# Service Bulletin

**SUBJECT:** Service Update for Inventory and Customer Vehicles  
Convertible Top Cosmetic Blemish  
Expires with Base Warranty

**MODELS:** 2013 Chevrolet Camaro Convertible

3402303

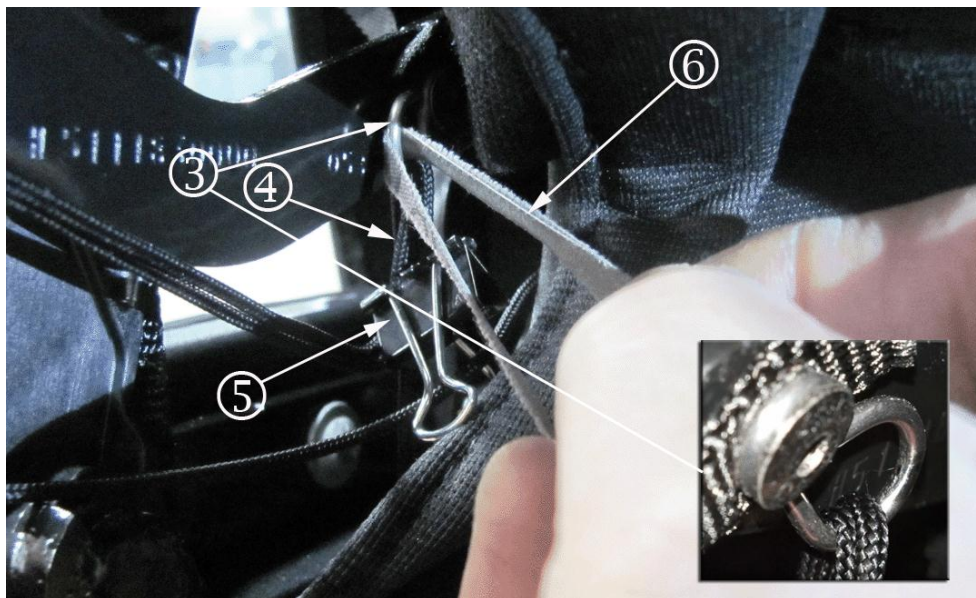
(1) Control Link (2) Control Link Front Eye Loop (3) Control Link Rear Eye Loop

3. Locate the control link rear eye loop (3). Refer to the inside of the control link to locate the rear eye loop.
